Monticello Nuclear Generating Plant
2807 W County Road 75
Monticello, MN 55362

L-MT-15-046
10 CFR 2.202
10 CFR 50.4

Monticello Nuclear Generating Plant Completion of Required Action by NRC Order
EA-12-051 Reliable Spent Fuel Pool Instrumentation (TAC No. MF0924)

Responses to Requests for Additional Information

Figure 1 - 1 – Spent Fuel Pool Levels

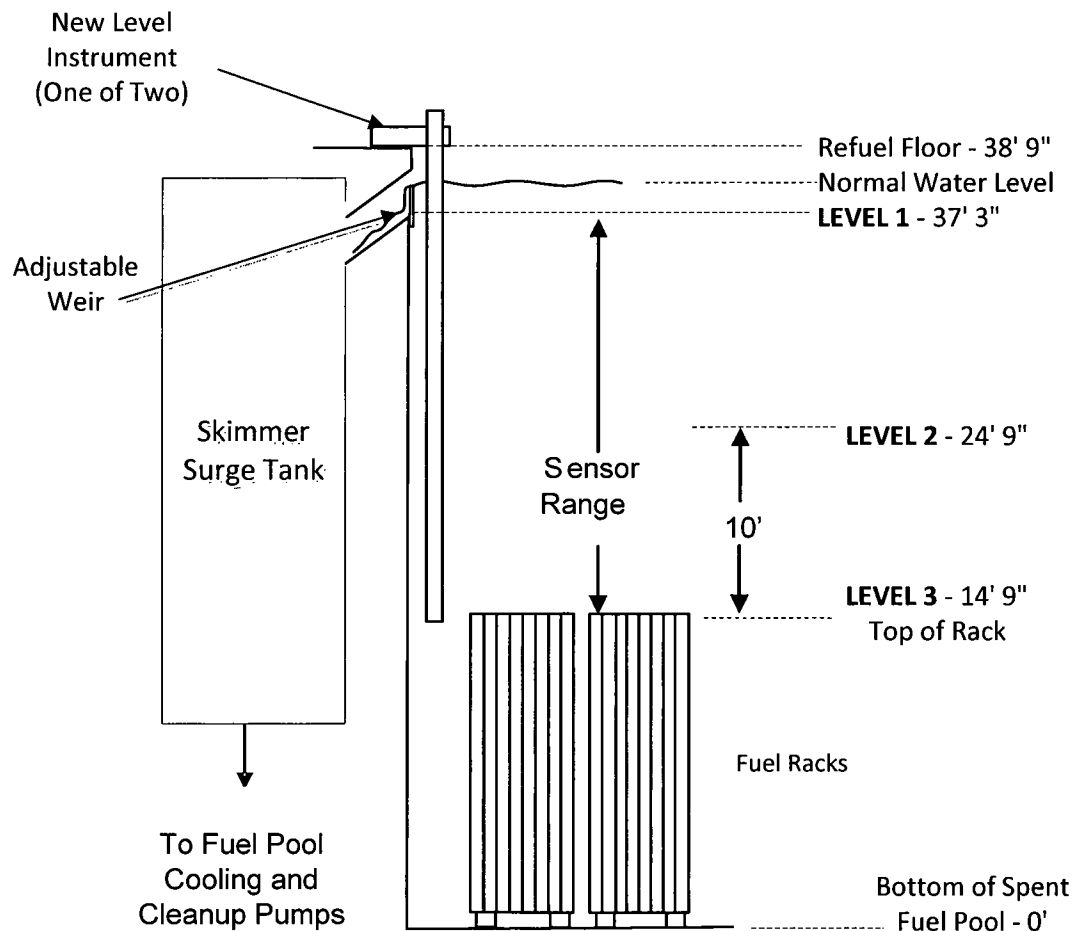
Given the potential for varied dose rates from hardware stored in the SFP, please provide a description of how the elevation identified as Level 2 might be affected.

For the MNGP Spent Fuel Pool, pool levels are defined in Figure 1 - 1 provided below:

- **Level 1** - Level that is adequate to support operation of the normal fuel pool cooling system.
- **Level 2** - Level that is adequate to provide substantial radiation shielding for a person standing on the spent fuel pool operating deck. NEI 12-02 indicates that selection of 10 feet between level 2 and level 3 assures a range of water level where any necessary operations in the vicinity of the spent fuel pool can be completed without significant dose consequences from direct gamma radiation from the stored spent fuel.
- **Level 3** – Level where fuel remains covered and actions to implement make-up water addition should no longer be deferred.

NSPM performed a calculation of the dose rates in the spent fuel pool at various levels in accordance with NEI 12-02. The results of the calculation indicated that the total integrated dose for the dielectric material is $9.79\text{E}+08$ rad. The instrument material is qualified for a total dose of 10 Grad, or $1.0\text{E}+10$ rad. Therefore, the qualified radiation dose for the material is greater than the calculated results and is acceptable.
